TVA-SQN-TS-00-06

SEQUOYAH NUCLEAR PLANT (SQN) - UNITS 1 AND 2 - REVISION OF INSTRUMENTATION MEASUREMENT RANGE, BORON CONCENTRATION LIMITS, REACTOR CORE LIMITATIONS, AND SPENT FUEL POOL STORAGE REQUIREMENTS FOR TRITIUM PRODUCTION CORES (TPCs) - TECHNICAL SPECIFICATION (TS) CHANGE NO. 00-06

PROPOSED TECHNICAL SPECIFICATION (TS) CHANGE TS 00-06 AND TPBAR CONSOLIDATION ACTIVITY DESCRIPTION AND EVALUATION OF THE PROPOSED CHANGE

Figure 5.6-1
Arrangements of Fuel Storage Regions in the Sequoyah Spent Fuel Storage Pool

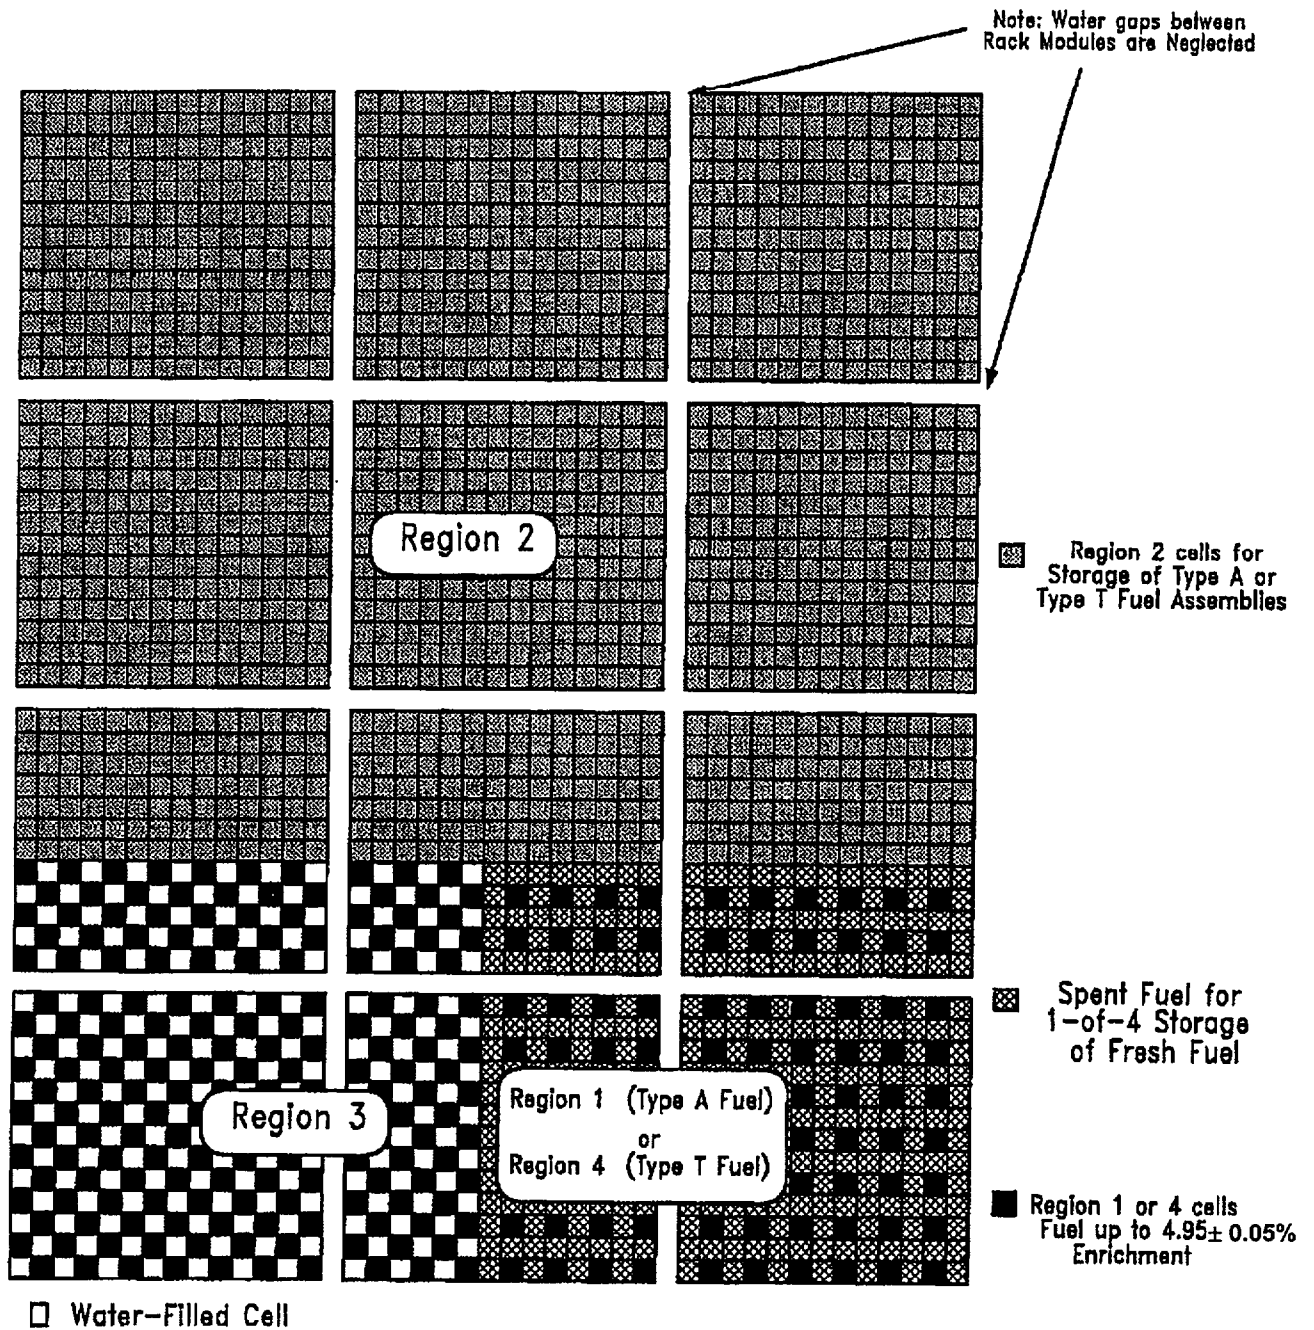
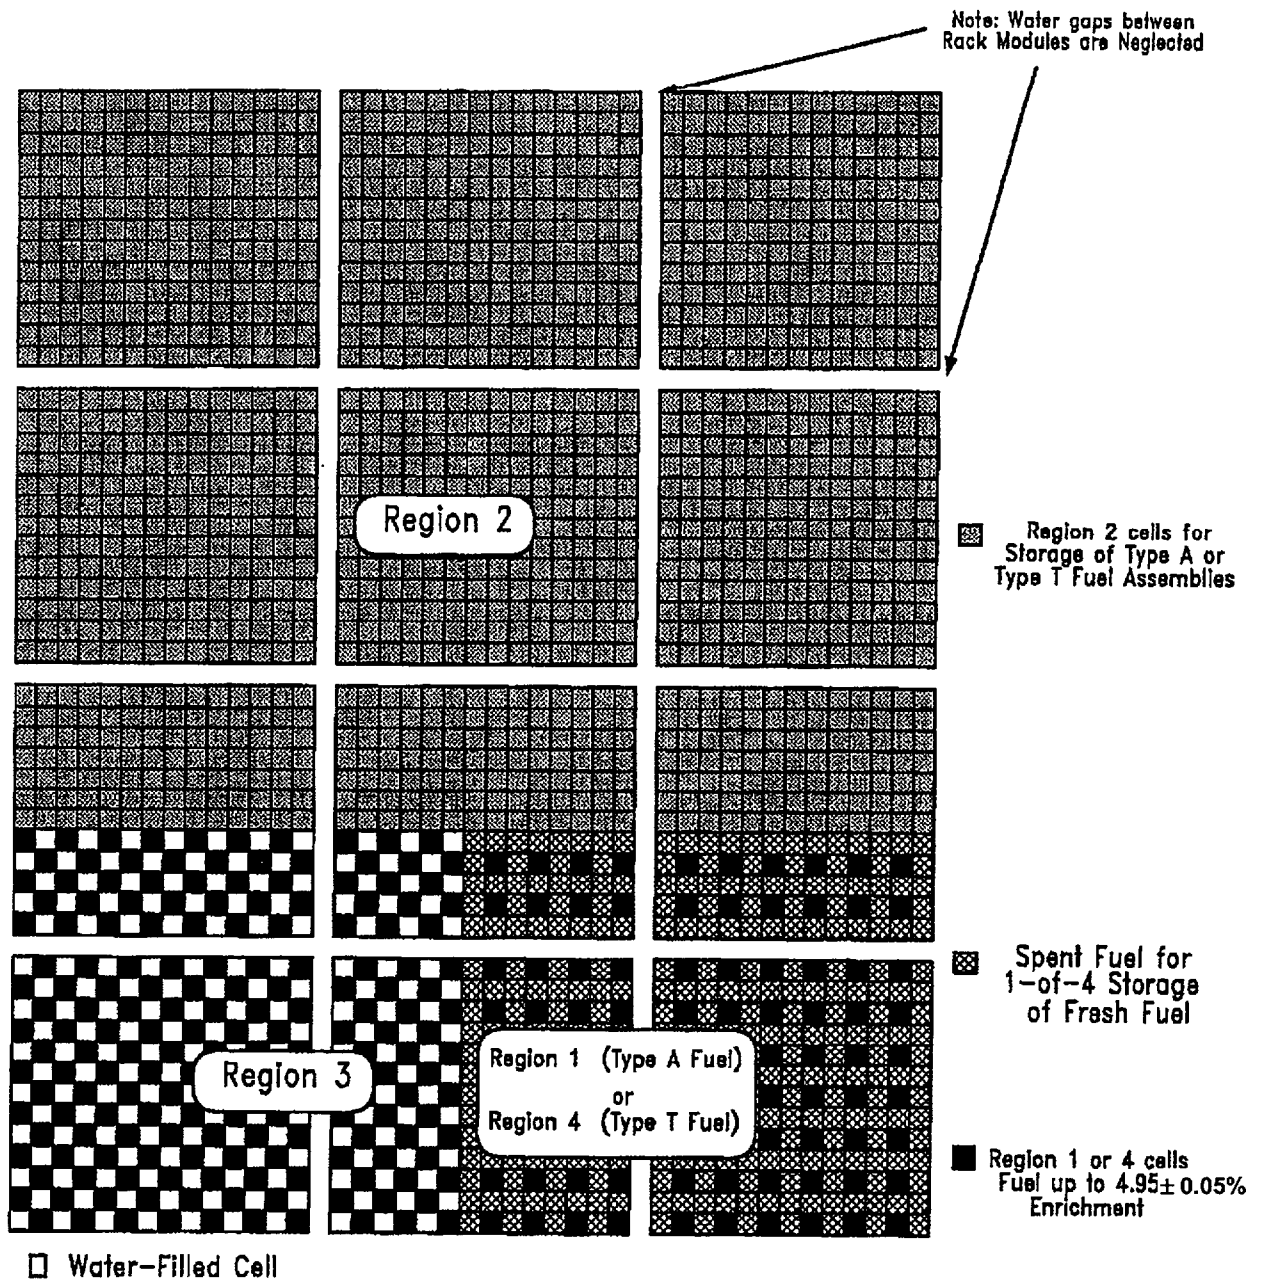
[Replace with Insert 12]

Note: The edges of the sketch above are not necessarily the edges of the pool. The Regions may appear anywhere in the pool and in any orientation, subject to the restriction in Design Feature 5.6.1.1.c.

Figure 5.6-1a
Acceptable Spent Fuel Pool Loading Patterns for Checkerboard Storage of Fresh and Spent Fuel Assemblies - Example

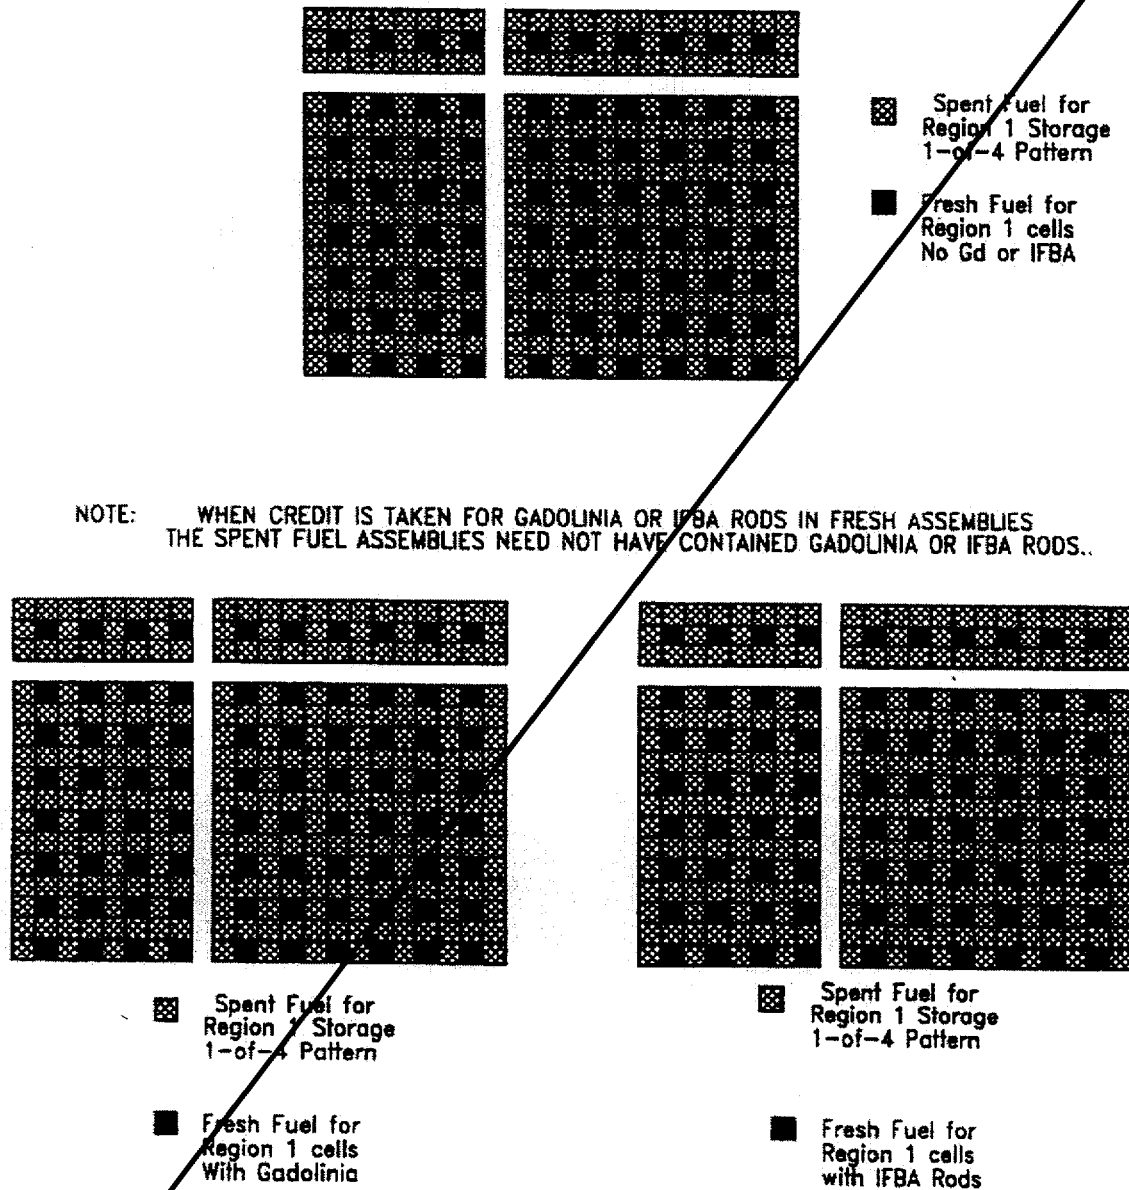
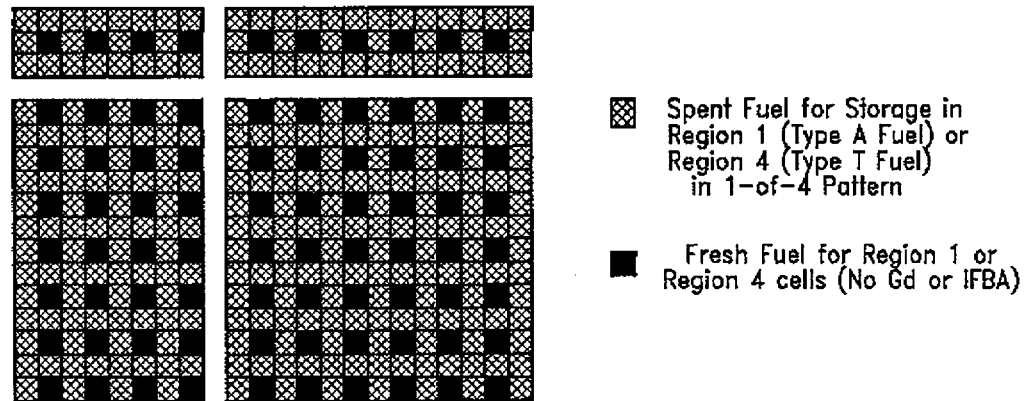
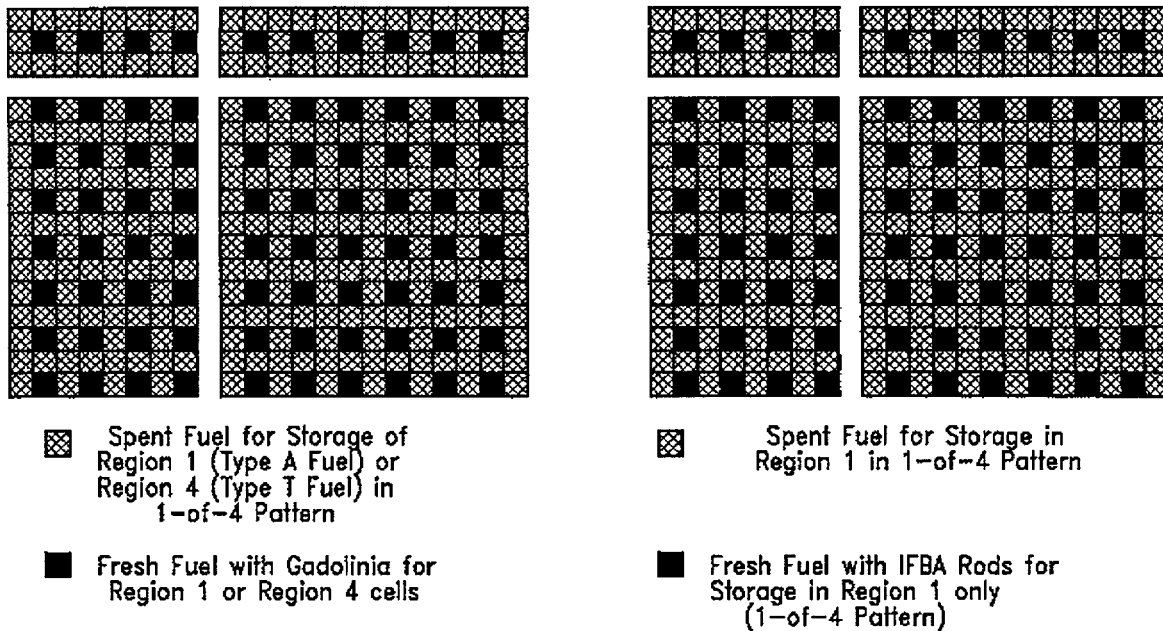
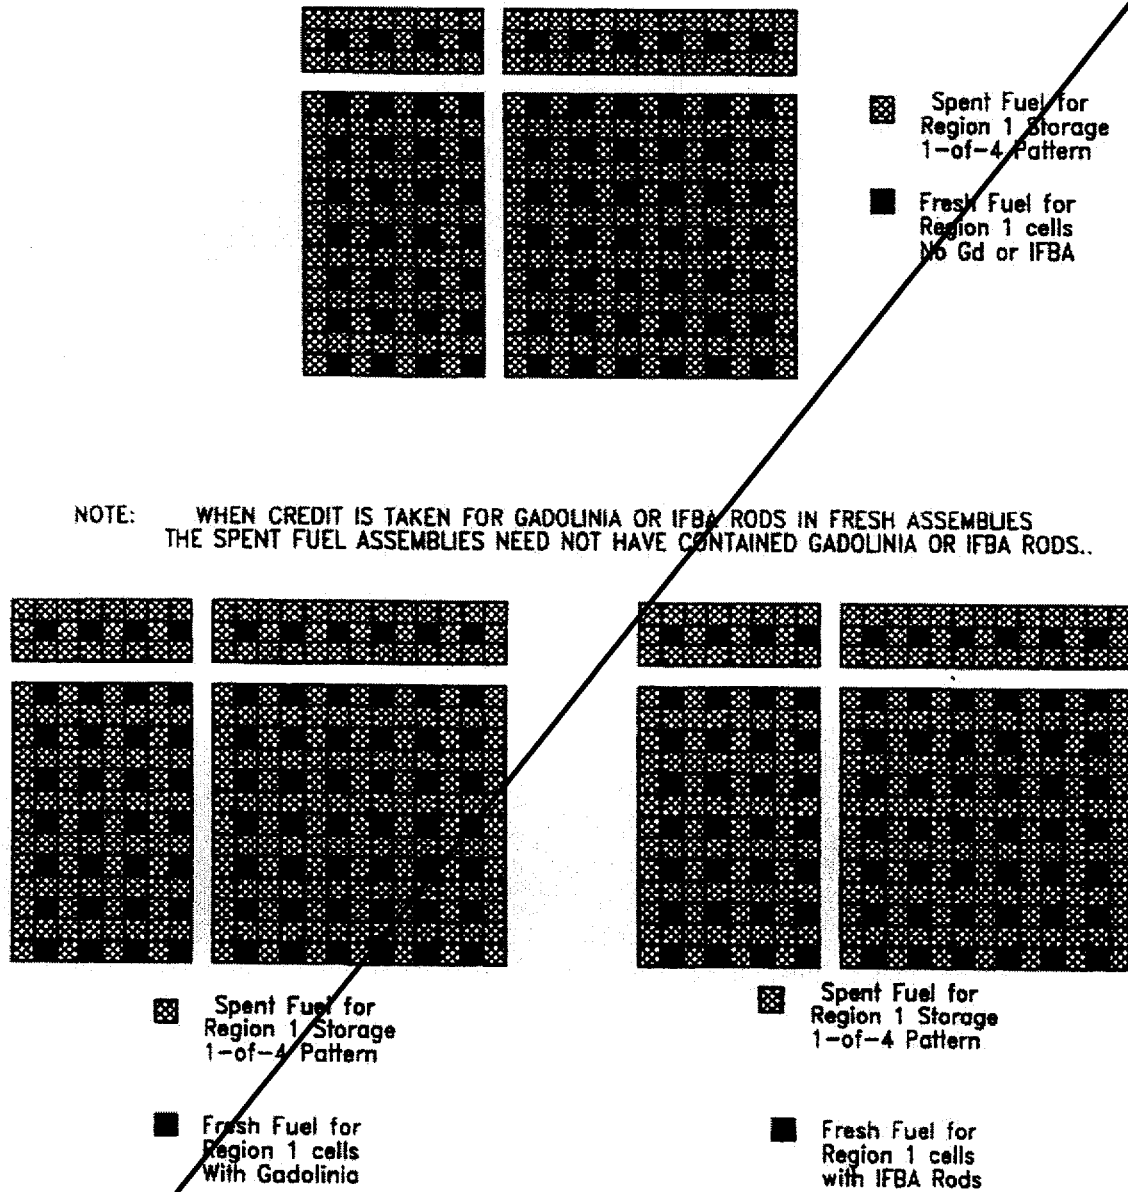
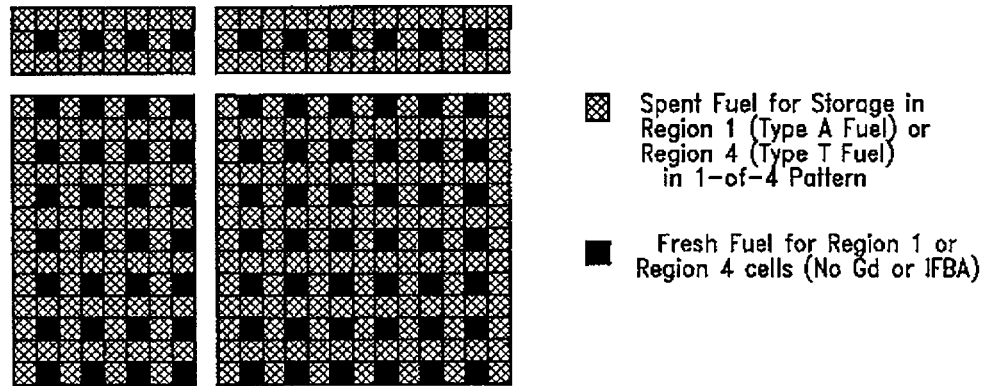
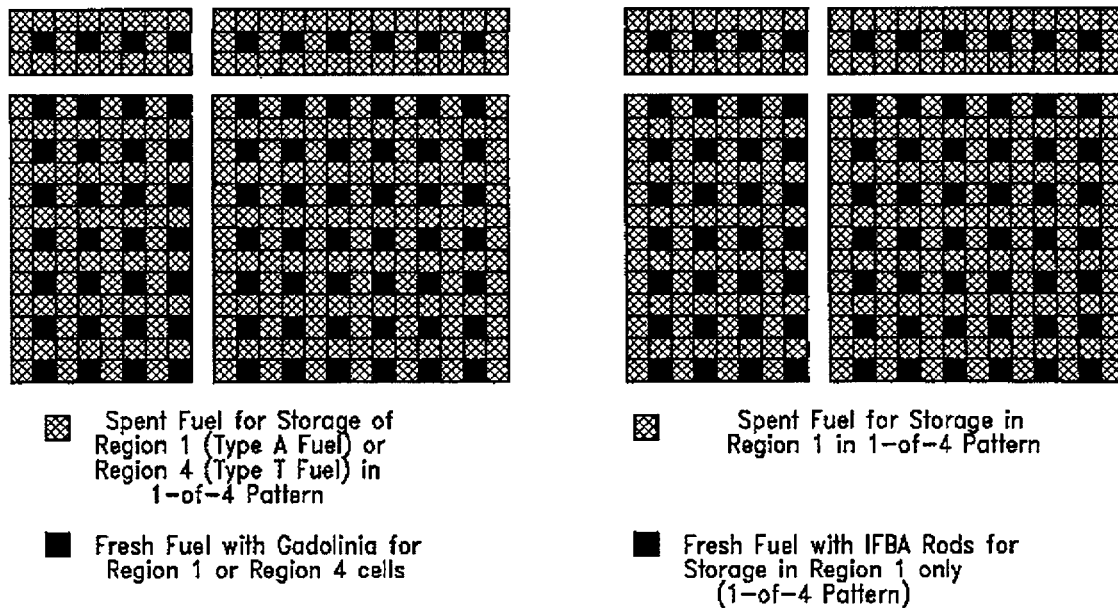
[Replace with Insert 13]

Insert 13

NOTE: WHEN CREDIT IS TAKEN FOR GADOLINIA RODS IN FRESH ASSEMBLIES THE SPENT FUEL ASSEMBLIES NEED NOT HAVE CONTAINED GADOLINIA RODS..

Fig. 5.6-4 Limiting Burnup Requirements in Region 2 for
Face Adjacent Storage of Type T Spent Fuel
Assemblies

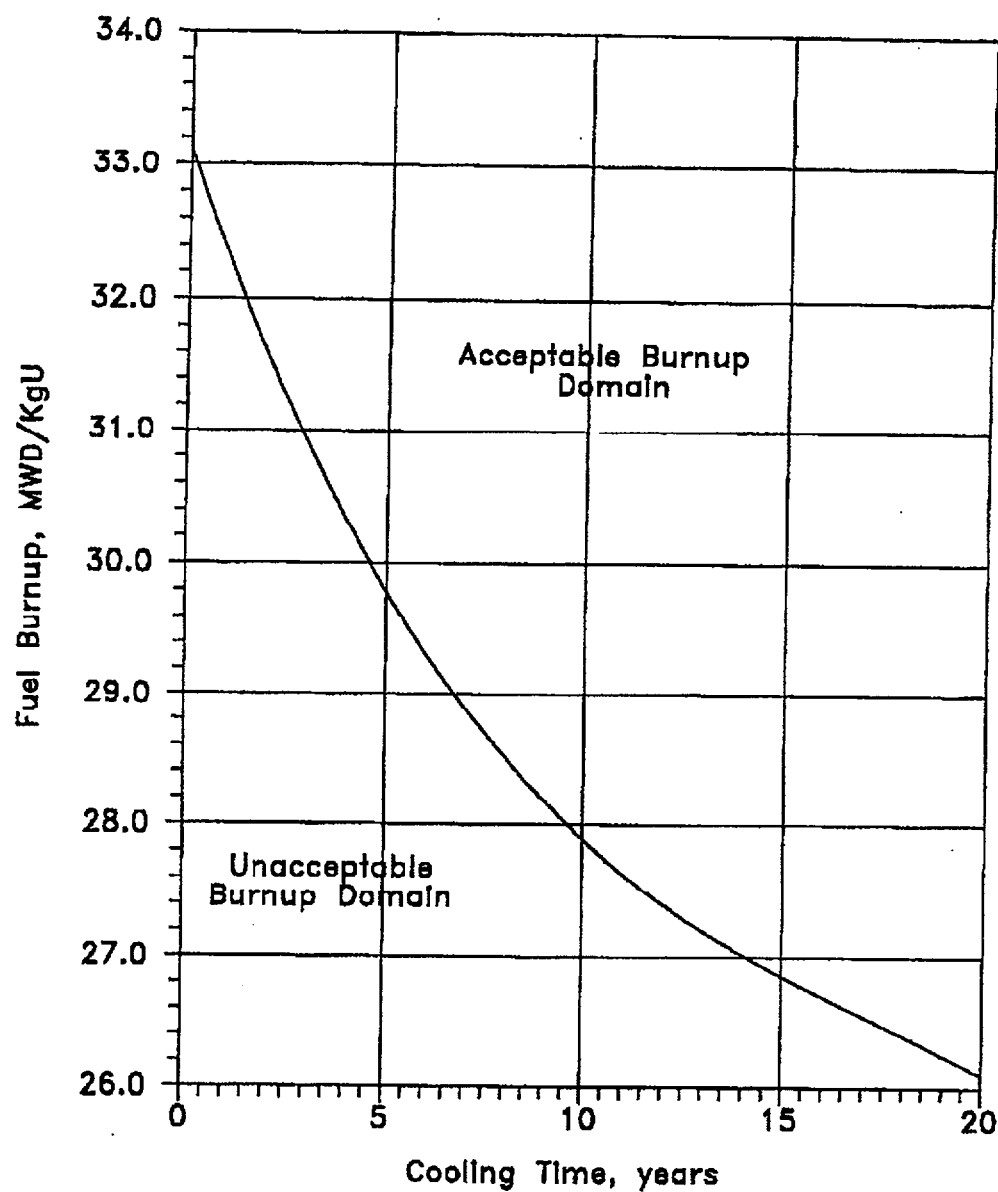
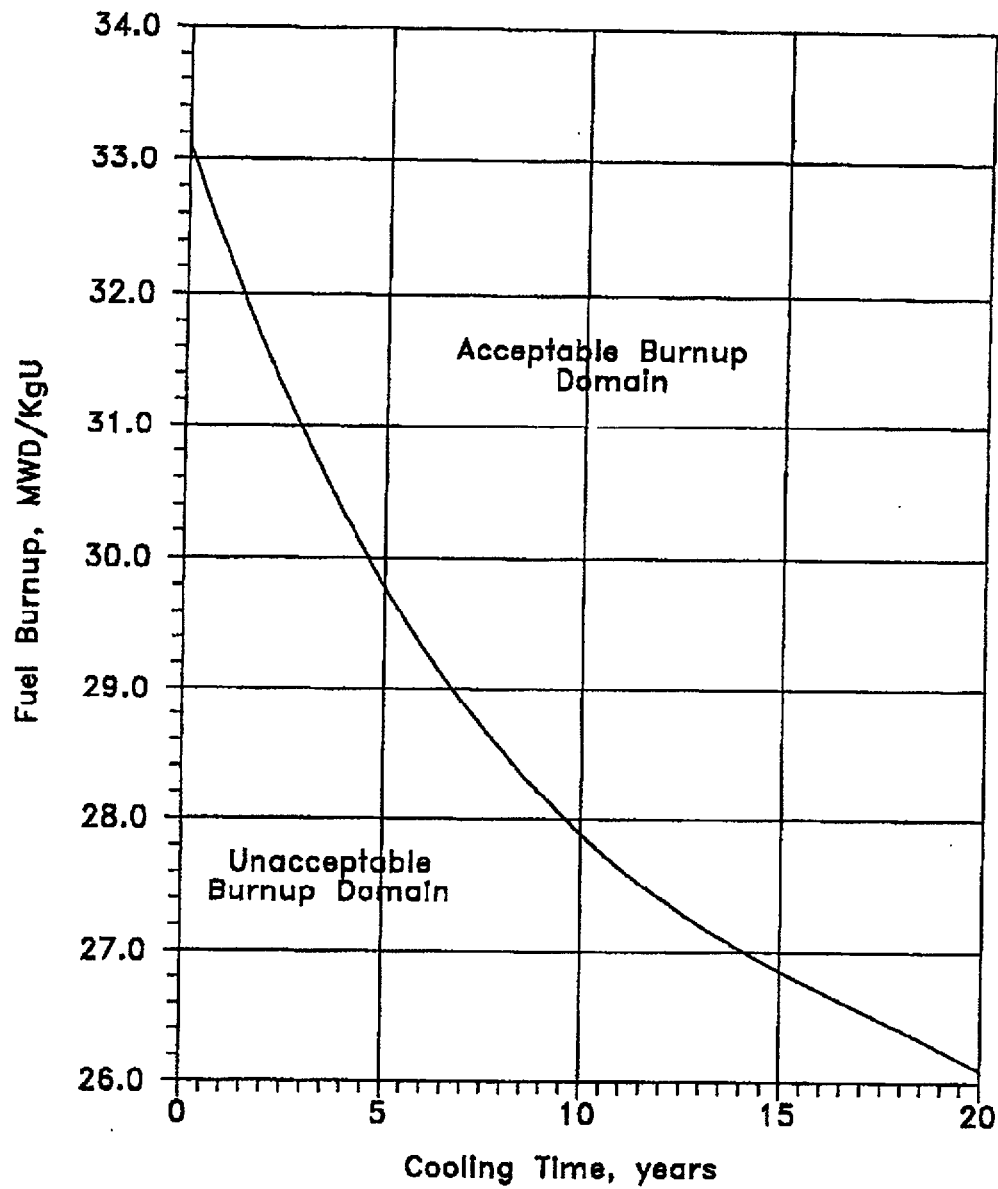
Insert 14
